NUMBER: 23-026-03

New Snap-In Retainer To Improve Retention Of Mopar Air Deflector To Hood

1999 - 2004 (WJ) Grand Cherokee (Domestic Markets)

Fig. 1 SNAP-IN RETAINER & HOOD SLOTS

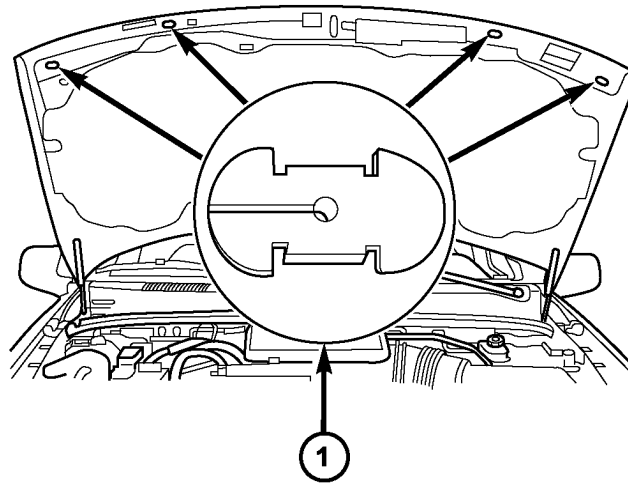
The Mopar front molded air deflector (bug shield) accessory is fastened to the underside of the hood. The inner hood panel has four slots to accommodate the air deflector plastic snap-in retainers. The customer may notice that the plastic snap-in retainers do not fully seat to the slots in the hood inner panel.

If the plastic snap-in retainers for the Mopar air deflector are not fully seated to the slots in the hood inner panel, perform the Repair Procedure.

Qty.	Part No.	Description
1	05134664AA	Package, Plastic Snap-In Retainer (4)

1. Remove the four (4) fasteners securing the air deflector to the hood and remove the air deflector (Fig. 1).
2. Install the new plastic snap-in retainers, p/n 05134664AA.
3. Install the air deflector to the hood.
